# AGENDA

## STATE BUILDING CODE TECHNICAL REVIEW BOARD

Friday, March 21, 2014 – 10:00 a.m.

In Re: Appeal of Milari Madison  
Appeal Nos. 13-3, 13-7 and 14-2

Picture "5" misaligned overhang, west wall, hole in sheathing

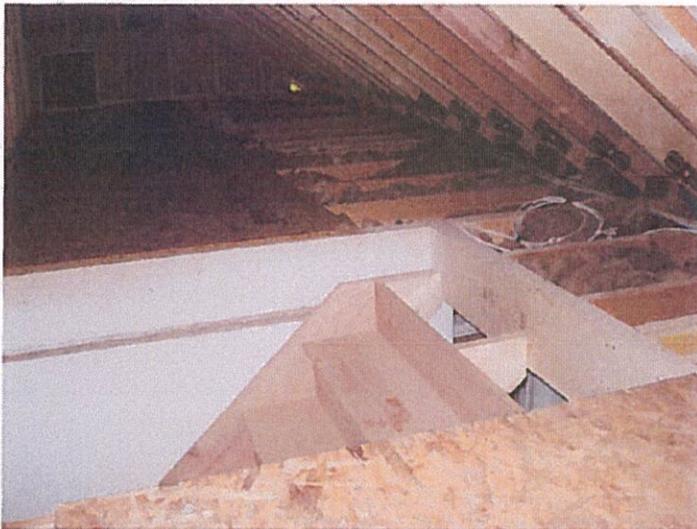
Picture "6" misaligned overhang, west wall. Inconsistent with Approved House Documen

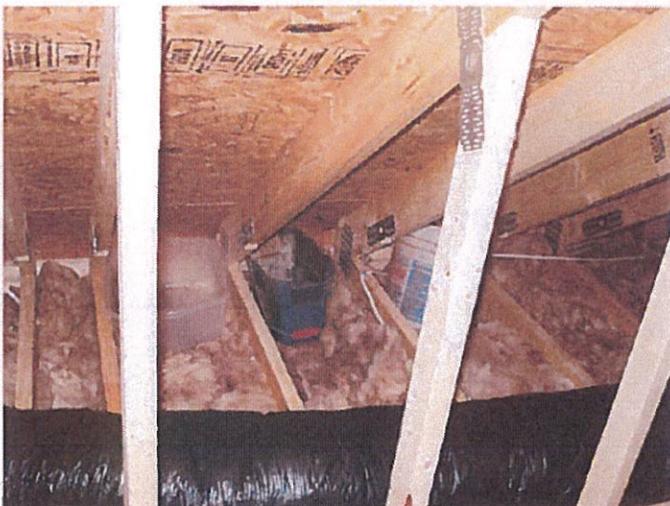
Picture "10" third floor, no thermal envelop, no headroom, unguarded opening. Inconsistent with Approved House Document. House as built is a 2 story cape.

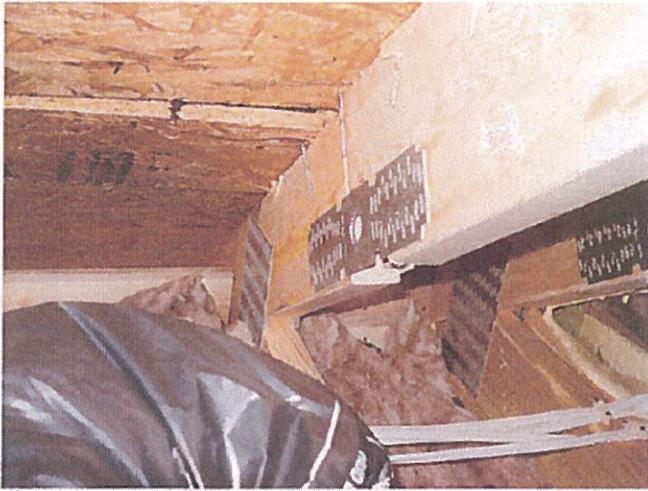
Picture "11" water damage to ceiling and wall below stairs to third floor, temporary guard to stairwell down to first floor installed by Madison to prevent injury. "Decent, safe, and sanitary dwelling" includes, in part, that a dwelling "is weather tight" (§ 36-106).

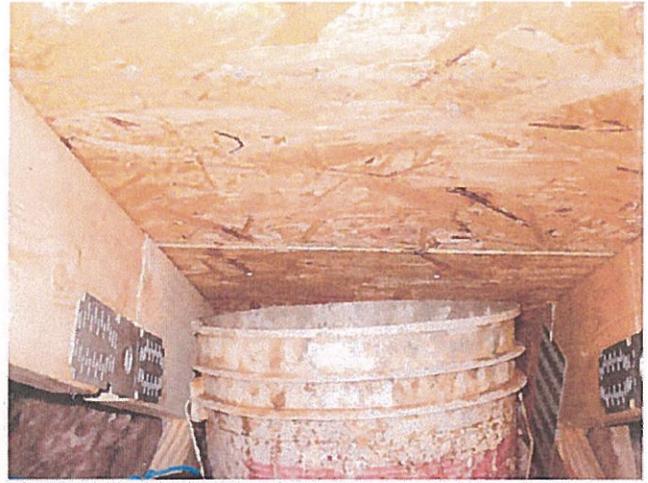
Picture "12" third floor/attic, behind knee wall, no thermal envelope, water containers prior to removal of insulation. "Decent, safe, and sanitary dwelling" includes, in part, that a dwelling "is weather tight" (§ 36-106).

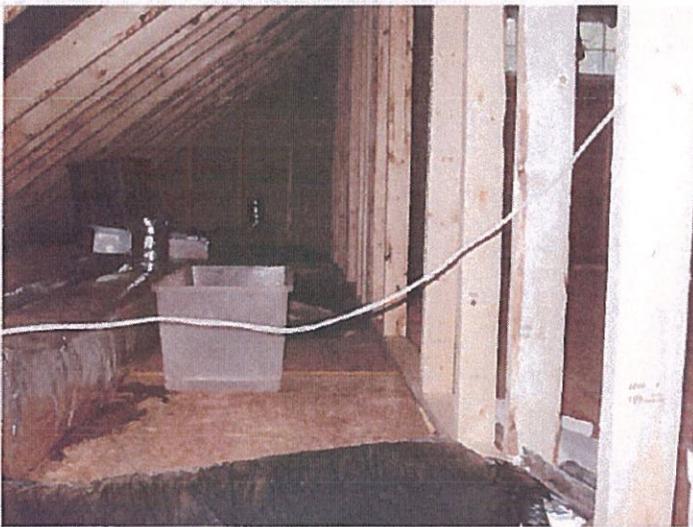
Picture "22" left side of wall up to attic/third floor not flush with interior wall and door entry to bedroom # 3. Inconsistent with Approved House Document.

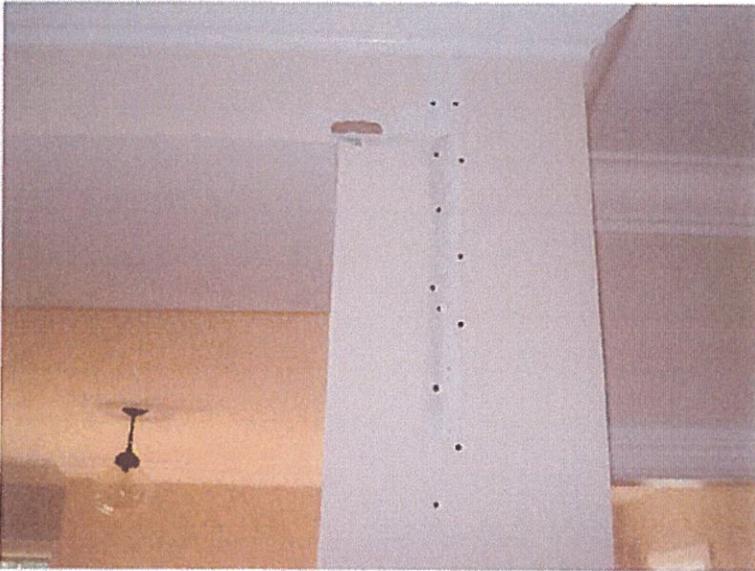
Picture "43" ongoing cracking in ceiling and walls, kitchen to den, one-story west wing

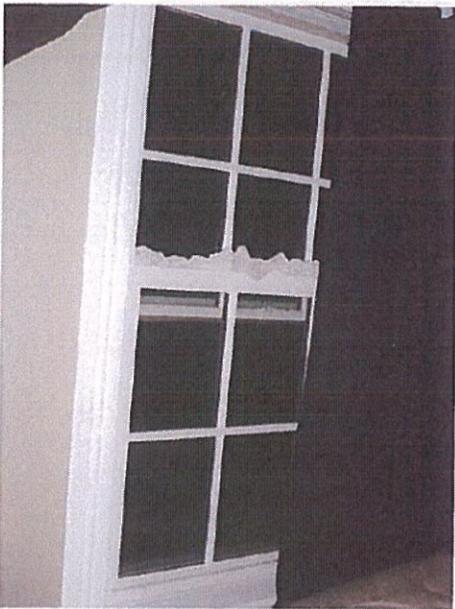
Picture "49" overhang not level. Chimney built out by Milton unlicensed staff. Size altered per Approved House Document. Failed to meet code and manufacturers' installation requirements. No stamped plan for repair work performed by Milton.

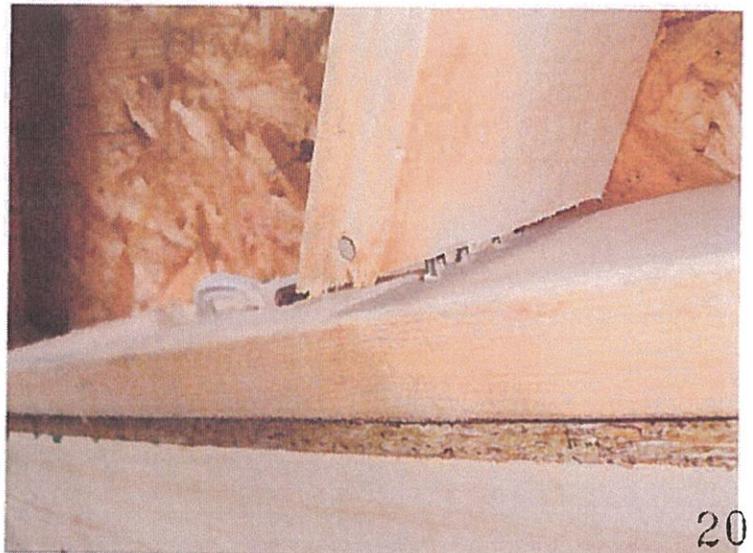
Picture "53" wrong size window, inconsistent with Approved House Document.

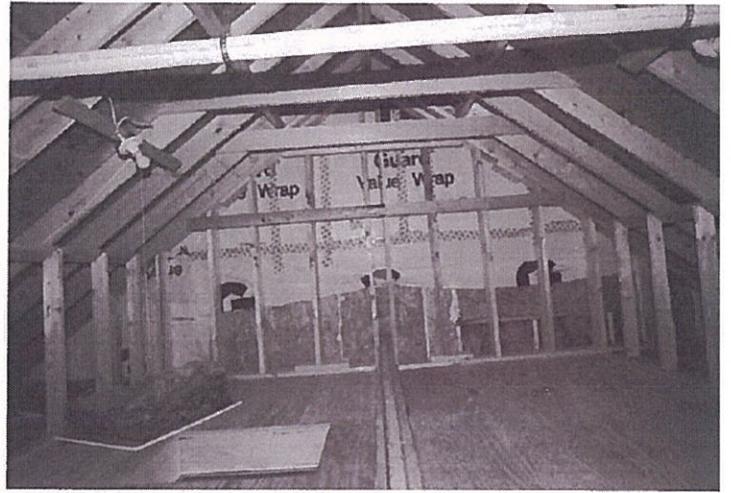
Den roof - missing collar ties
